LOWER MANHATTAN COASTAL RESILIENCY PROJECT – BATTERY

Public Design Commission Final Submission Review
August 8, 2022

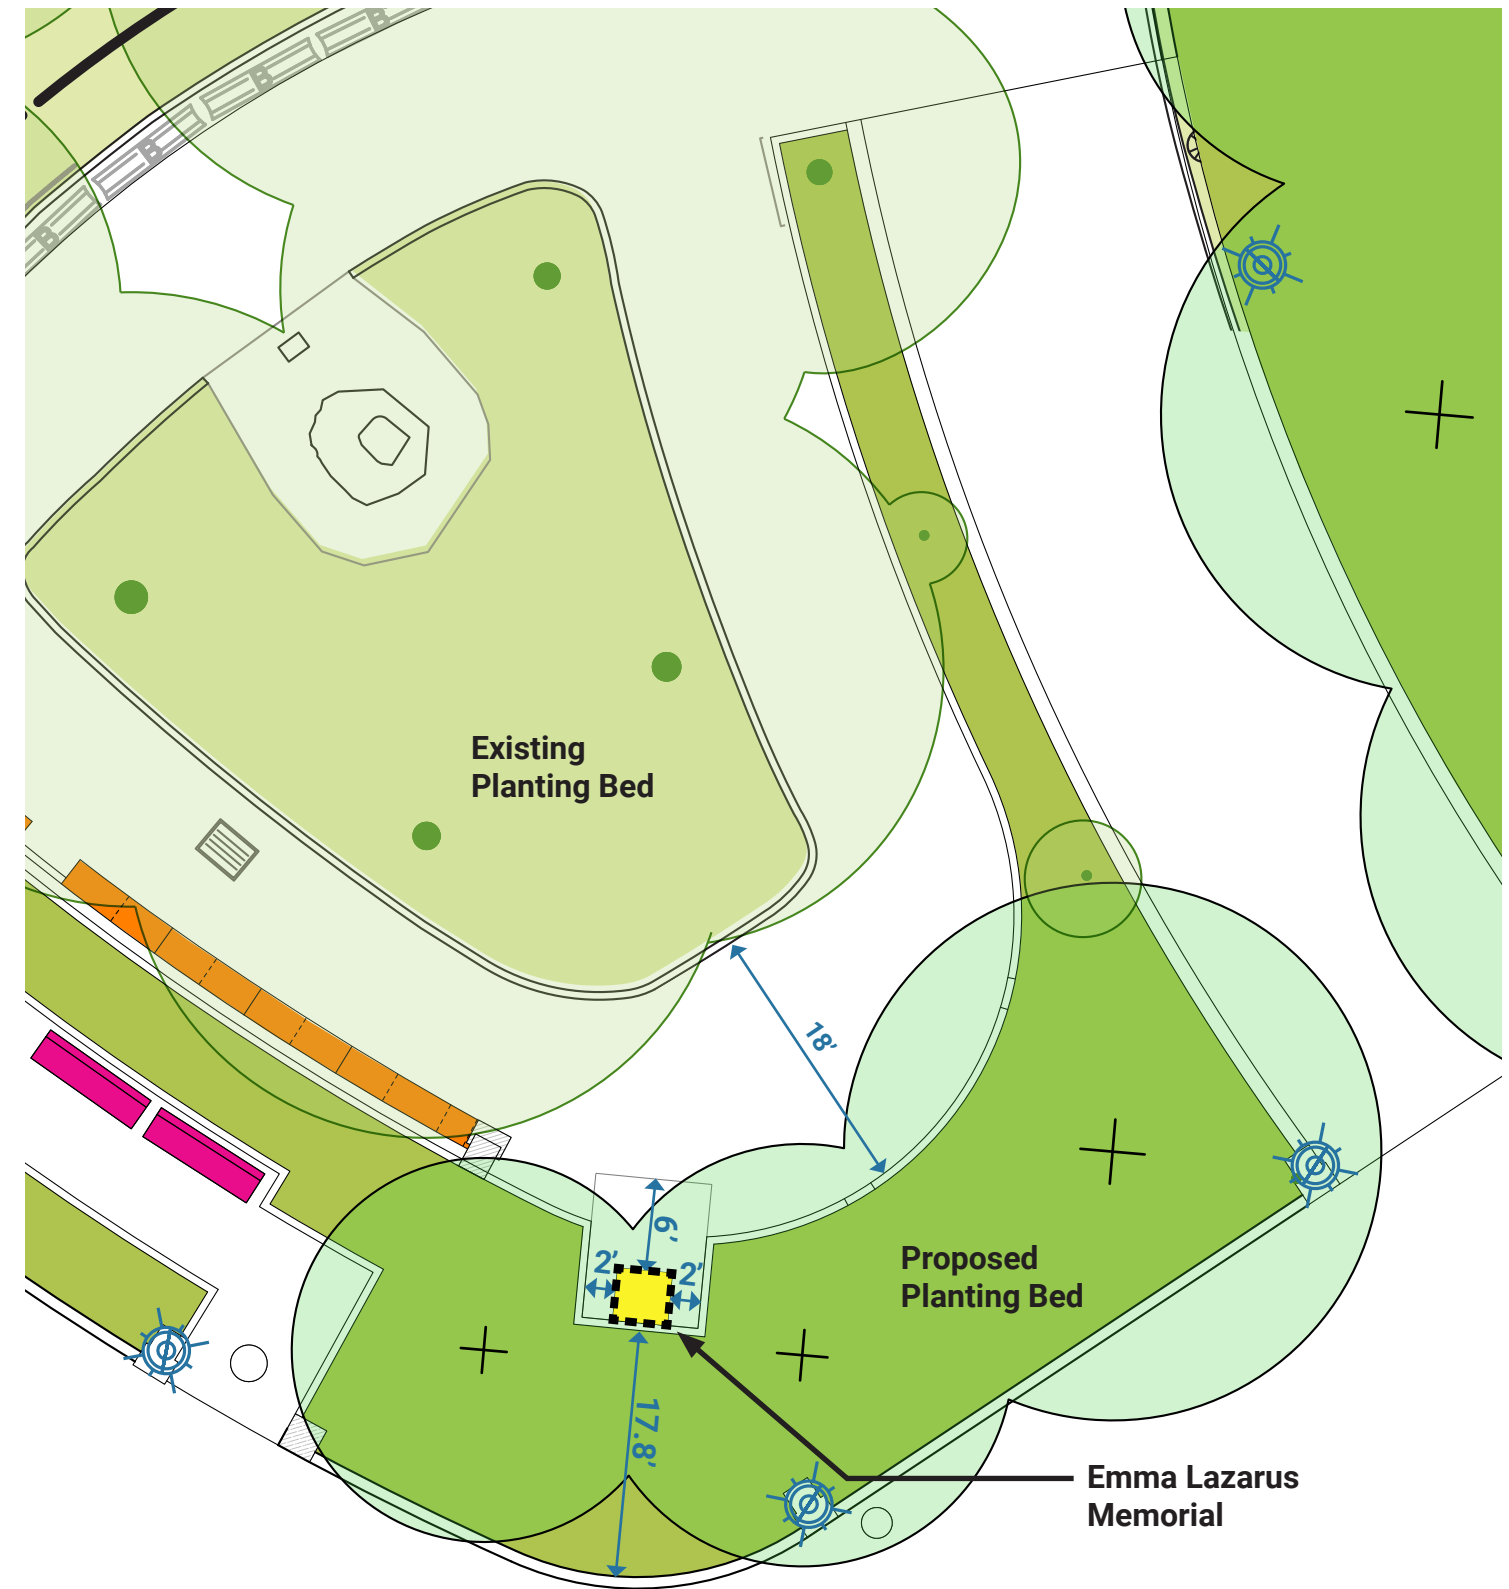
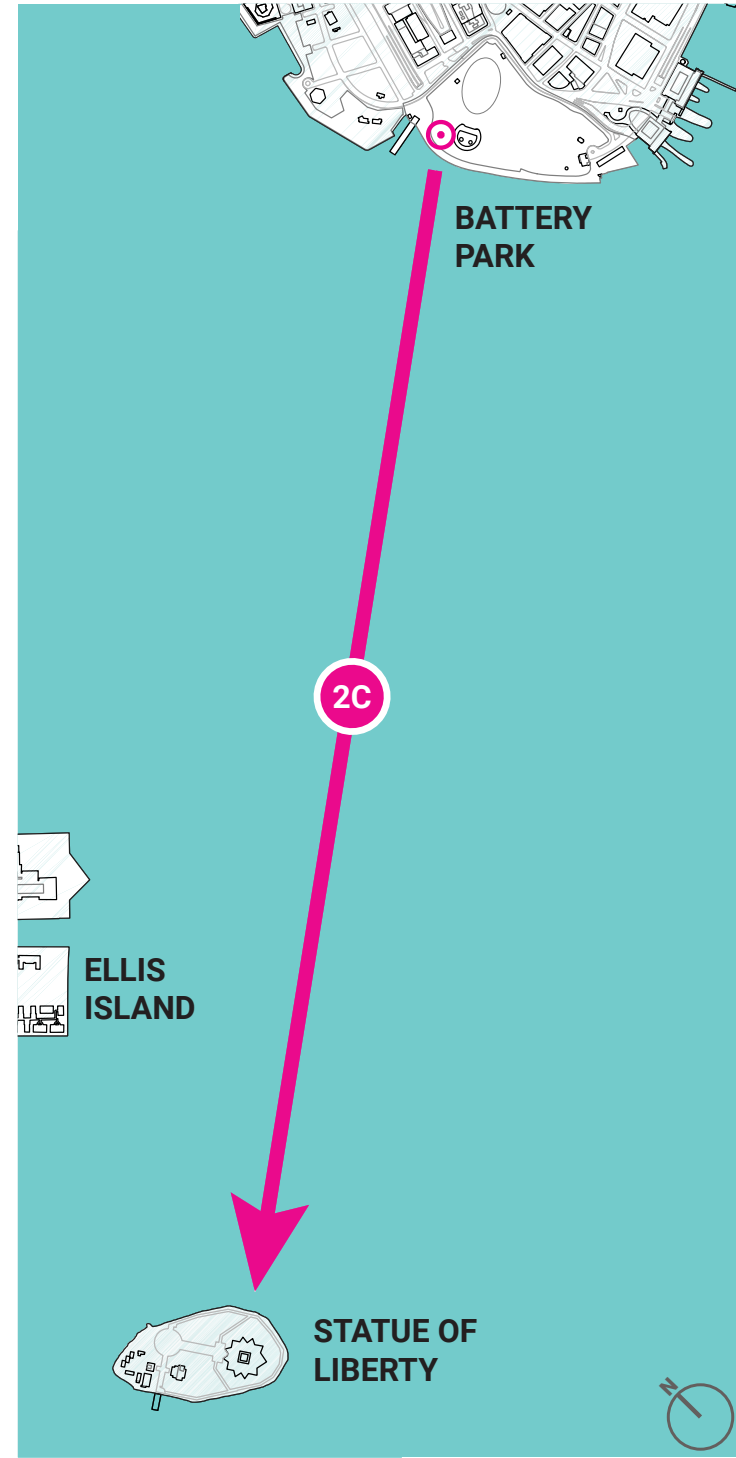
- 2A** The Emma Lazarus Memorial has been relocated towards the southwest per request of Parks to prevent damage from skateboards and vehicles
- 2B** The memorial is protected by planting on three sides.
- 2C** The proposed location has a direct view of Statue of Liberty in its background.

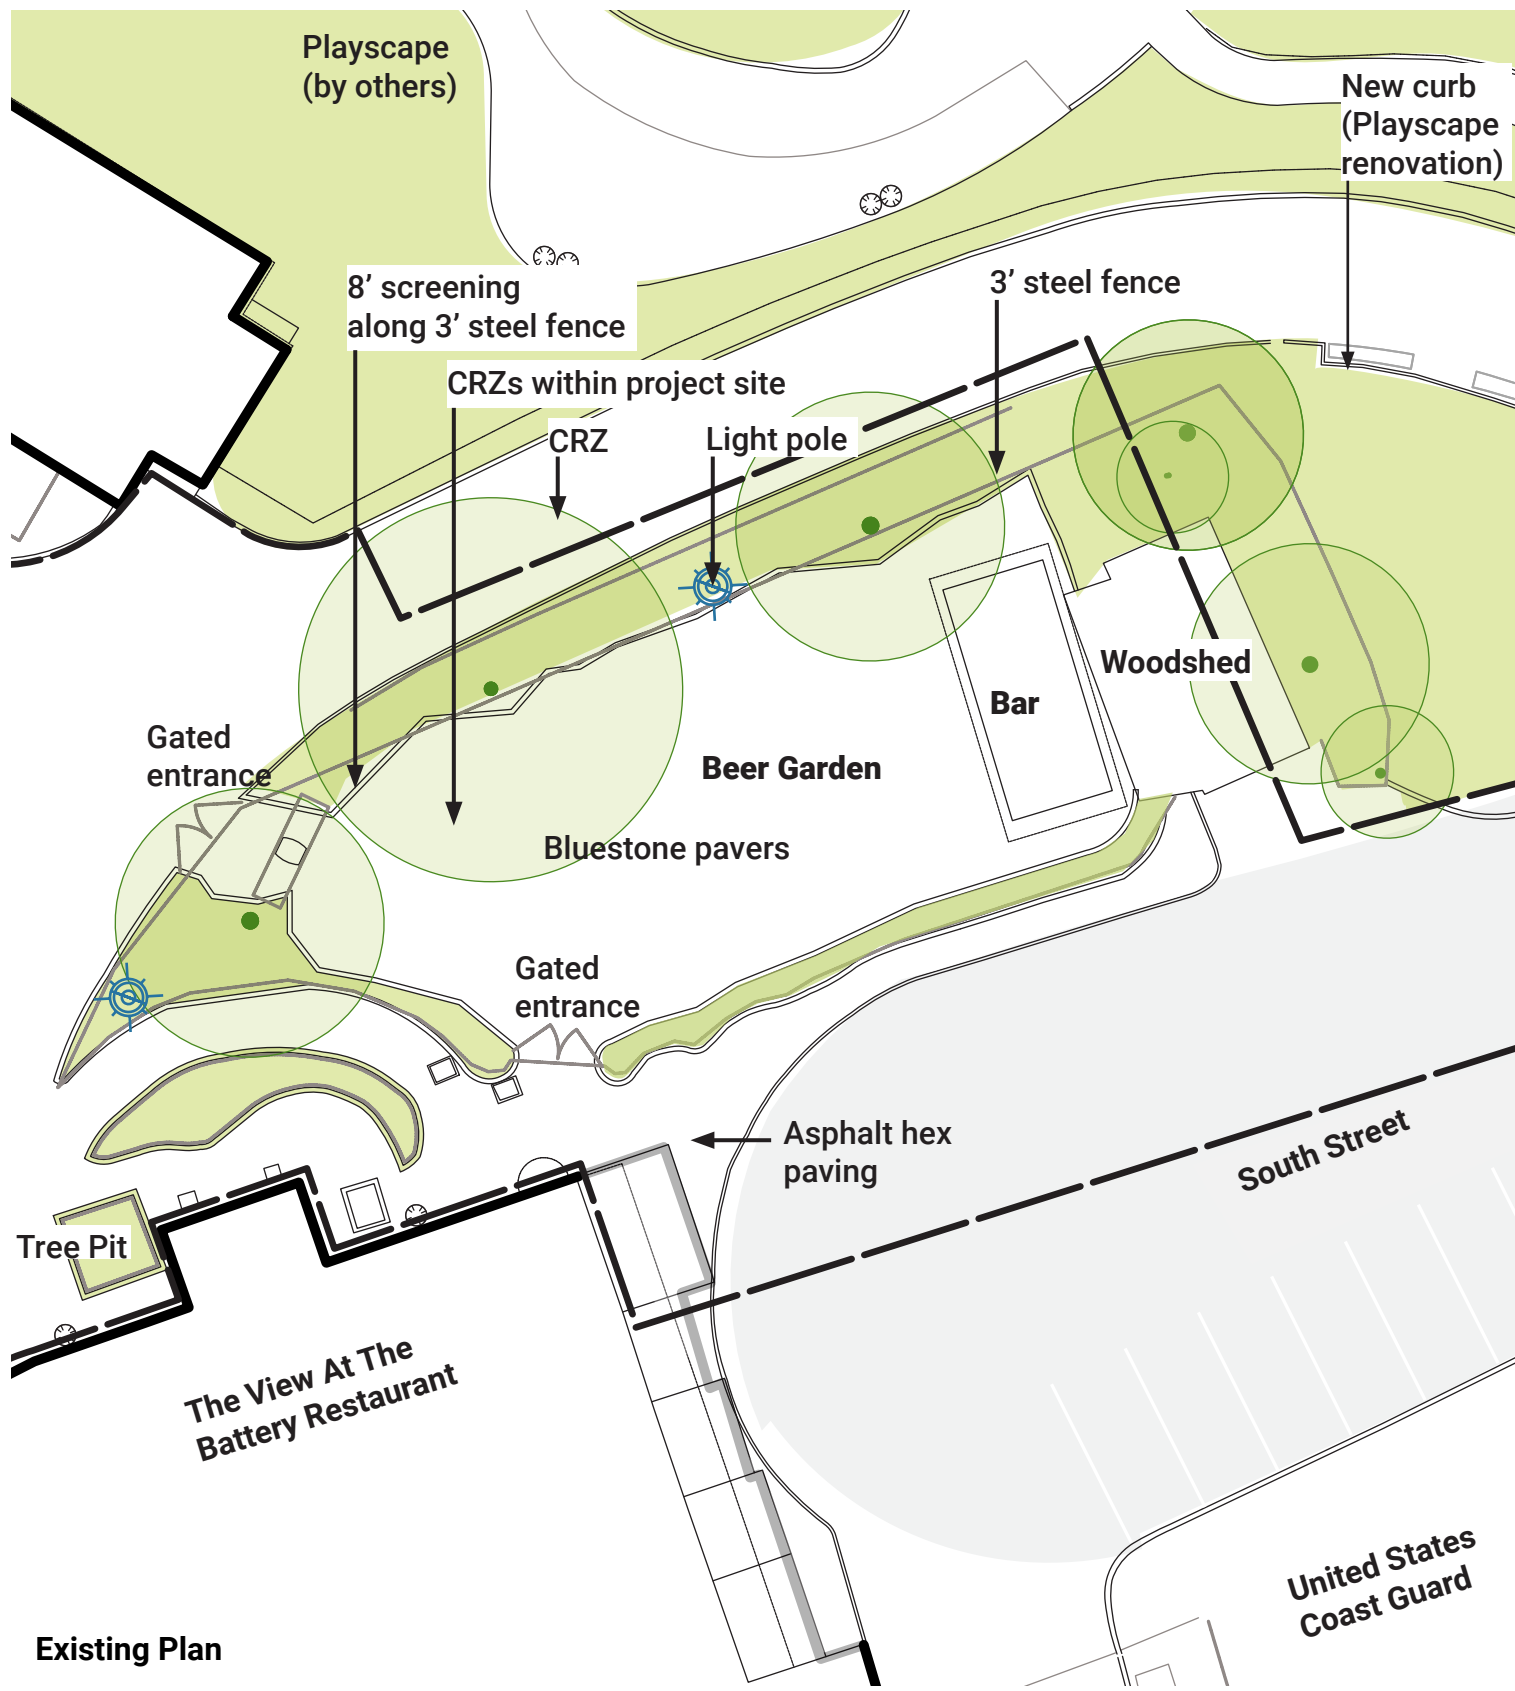
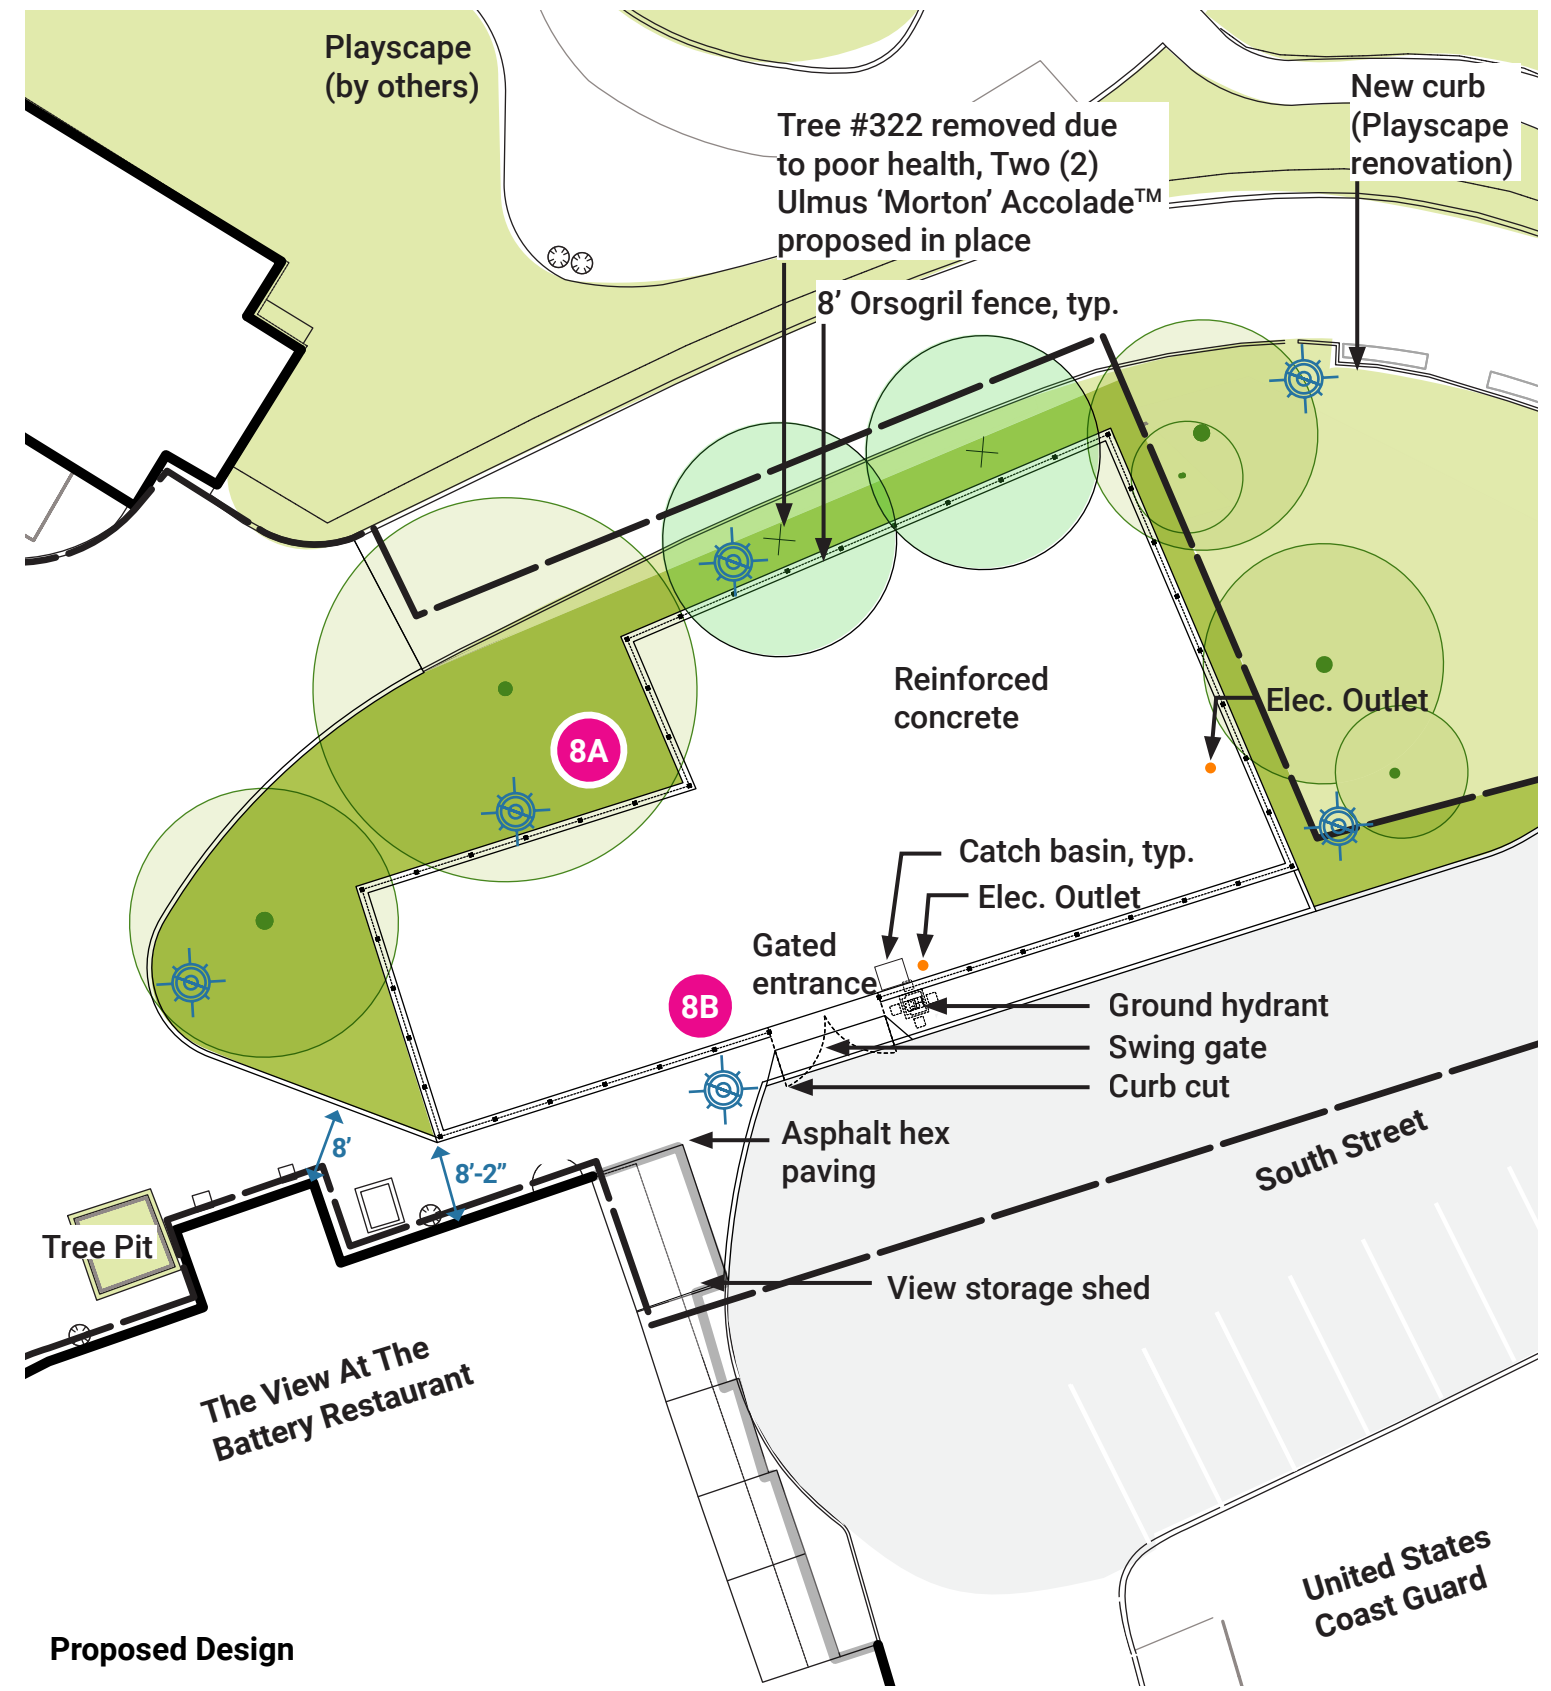
- 8A** Adjustment of the footprints of the paved area and surrounding planting
- 8B** Further development of the fence and gate design materials

- Tree #332 removed to provide additional space for M&O area
- New pavement minimizes impacts to CRZ's to provide more M&O space for operations
- Pavement installed at existing beer garden elevation to reduce impacts to trees (drop curb located at gated entrance)
- Paved area will provide secure space for DPR M&O storage containers and vehicles, all of which are fence height or lower.
